Serial No. : 10/507,042
Filed : September 7, 2004

REMARKS

FIG.7
(Prior Art)

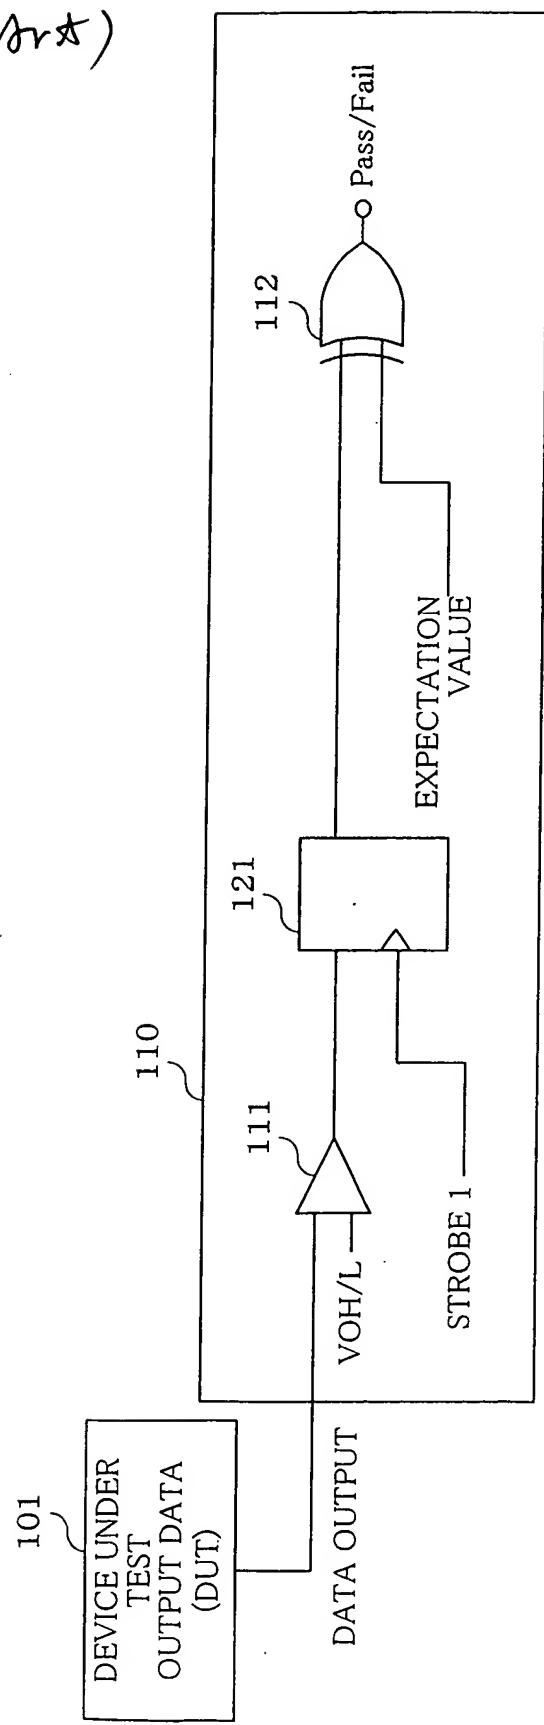
In the office action, the examiner objected to the drawings on the ground that Figures 8 and 9 lack a legend indicating the prior art. In the specification, the applicant incorrectly indicates Figure 8 as showing a conventional technology. In fact, Figure 7 shows the conventional technology rather than Figure 8. Accordingly, the applicant has submitted concurrently herewith a request for approval of drawing changes in which a "Prior Art" legend is added to Figures 7 and 9 as marked by red ink. The applicant has also submitted replacement sheets for the amended drawings.

In the office action, the examiner rejected Claims 1-10 under 35 U.S.C. 102(a) as being anticipated by the admitted prior art disclosed in the instant application with reference to Figure 8. As briefly noted above with respect to the amendment in the drawings, the applicant inadvertently referred to Figure 8 as showing the conventional technology while, in reality, Figure 8 shows the detailed structure of the second embodiment of the present invention. The structure of the conventional semiconductor test apparatus is shown in Figure 7. In other words, the applicant has intended to describe the conventional technology with reference to Figure 7 rather than Figure 8.

For example, in the specification, from page 1, line 26 to page 3, line 1, the description regarding the background art includes reference to a conventional LSI tester 110, a level comparator 111, a pattern comparator 112, a flip-flop 121. Such components are found only in Figure 7 but not in Figure 8. In contrast, the description from page 65, line 16 to page 69, line 28 regarding the second embodiment of the present invention, includes reference to a jitter detection circuit 60, registers 41a-41n, a subtraction circuit 61, a jitter limit value register

The applicant has submitted concurrently herewith a request for approval of drawing changes in which a "Prior Art" label is added to Figure 7 and Figure 9. The applicant has also submitted replacement sheets for the amended drawings.

62, and a comparison judgement circuit 63. Such components are found only in Figure 8 but not in Figure 7. Therefore, there is a clear error in the specification that the applicant has inversely labeled Figure 7 and Figure 8. Accordingly, the applicant has amended the specification to correct the clear error. As noted above, the applicant has also amend the drawing to add the "Prior Art" label to Figures 7 and 9.
